# Porsche Carrera Cup France 2022

## Note Technique 11/2022

### ROULEMENT A ROULEAUX CYLINDRIQUES BV

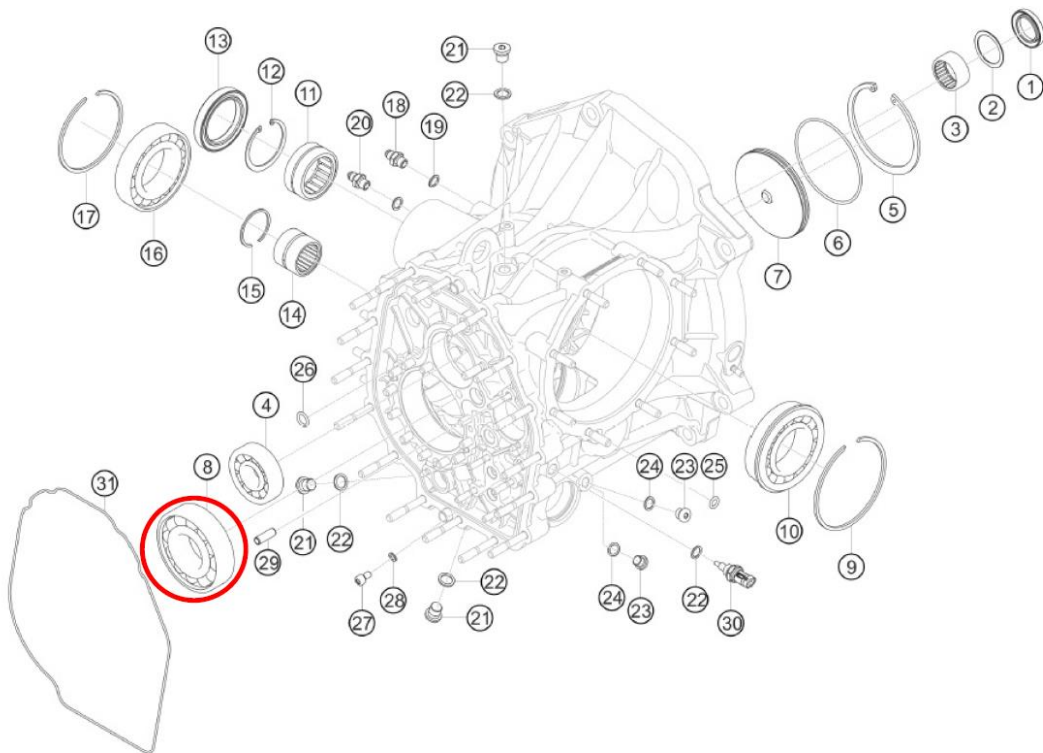
Porsche Motorsport vous informe que sur toutes les Porsche 992 GT3 Cup, le roulement à rouleaux cylindriques d'arbre secondaire (pos. 8) situés derrière le roulement 4-points, doit être changé par la nouvelle version lors de votre prochaine révision BV.

Cette nouvelle version confère une meilleure tenue dans le temps. La durée de vie maximale du roulement reste toutefois de 60h, ce qui correspond à l'intervalle habituel de révision BV.

Ancienne ref.	Nouvelle ref.	Description	Qté par BV
9F1.311.440.A	9F1.311.440	Roulement à rouleaux cylindriques	1

## GEARBOX CYLINDRICAL ROLLER BEARING

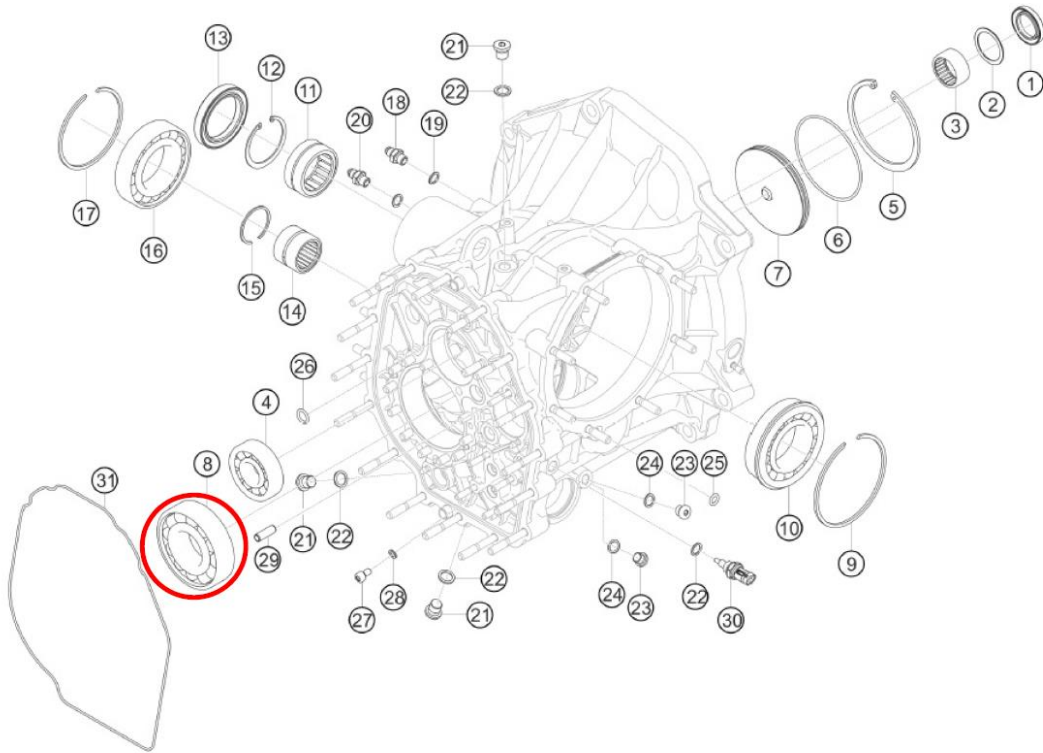
Porsche Motorsport informs that on all type Porsche 911 GT3 Cup (992) cars, the pinion shaft cylindrical roller bearing (8), behind the four-point bearing, must be changed for a new version during the next gearbox rebuild. The new version has improved long-term durability. The maximum permitted runtime for the bearing remains 60 hours (corresponds with a standard rebuild interval).

Part number (old)	Part number (new)	Description	Qty per car
9F1.311.440.A	9F1.311.440	Cylindrical roller bearing	1
